**ADDENDUM NO. 1
CITY OF PEORIA
Glen Avenue Improvement
May 31, 2022**

Re: Addendum for Bid Package, Glen Avenue Improvement – War Memorial Drive to University Street, Peoria, IL

PROPOSED TYPICAL SECTIONS

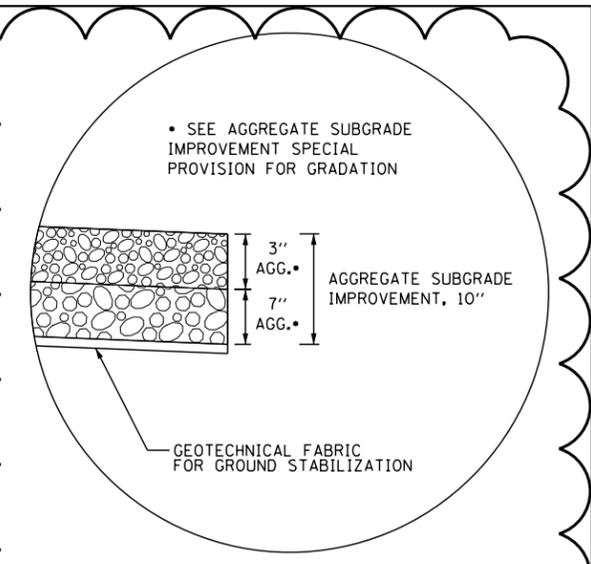
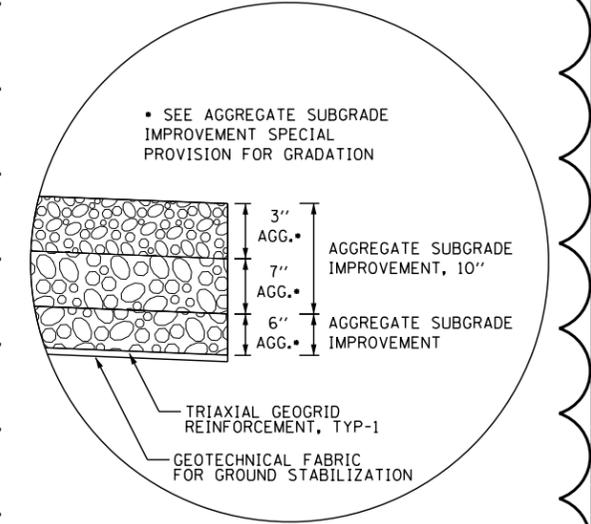
- 1) **PROPOSED TYPICAL SECTION** (Sheet 14 & 15)
 - The IBV values for each detail were revised such that the Aggregate Subgrade Improvement (ASI), 10” detail applies to IBV values greater than or equal to 4 and the other detail which adds the ASI (tons) applies to IBV less than 4.
 - The geogrid was removed from the ASI, 10” detail and added to the other detail with the additional the ASI (tons)
 - There are no changes to plan Quantities.
